Service Letter SL 60	DO - No. EASA.21J.020
--	---------------------------------	----------------------------------

Modification of Counterweight Body A-1496-() Y()

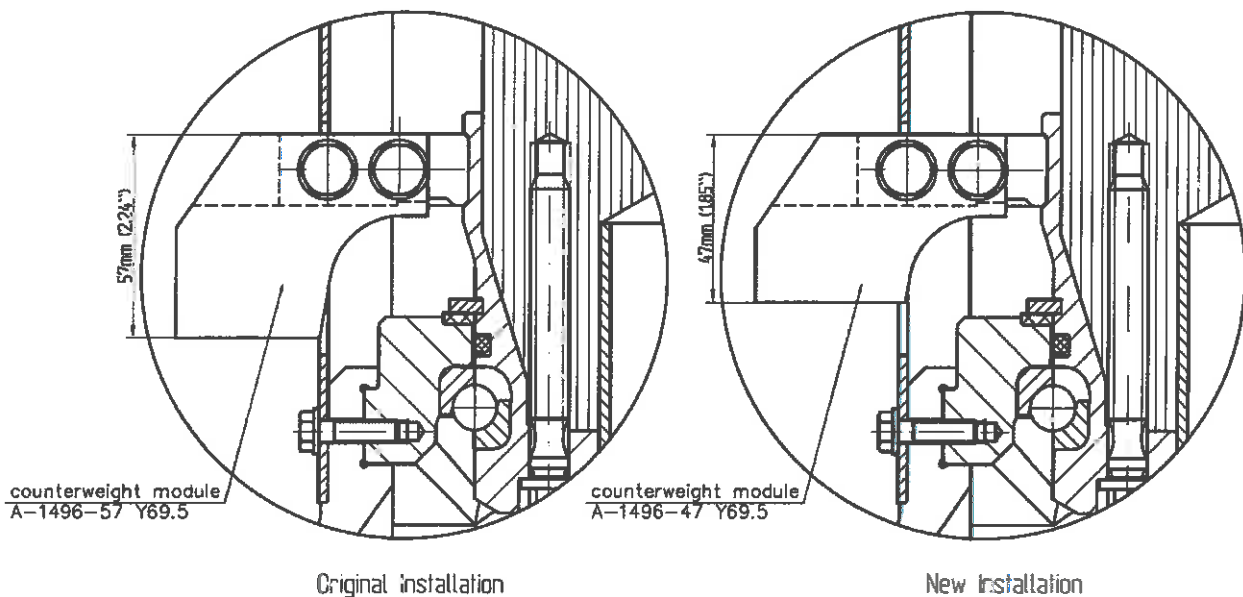
Counterweight body A-1496-57 Y69.5 must be modified to Counterweight body A-1496-47 Y69.5 by reducing the total height by 10mm or a new counterweight body.

Reduction of loads on pitch change parts and therefore reducing the long time wear.

This modification reduces the wear due to reduced loads by 60% on the pitch change parts.

Individual replacement is not allowed, only a complete set of 4 counterweight bodies per propeller must be replaced.
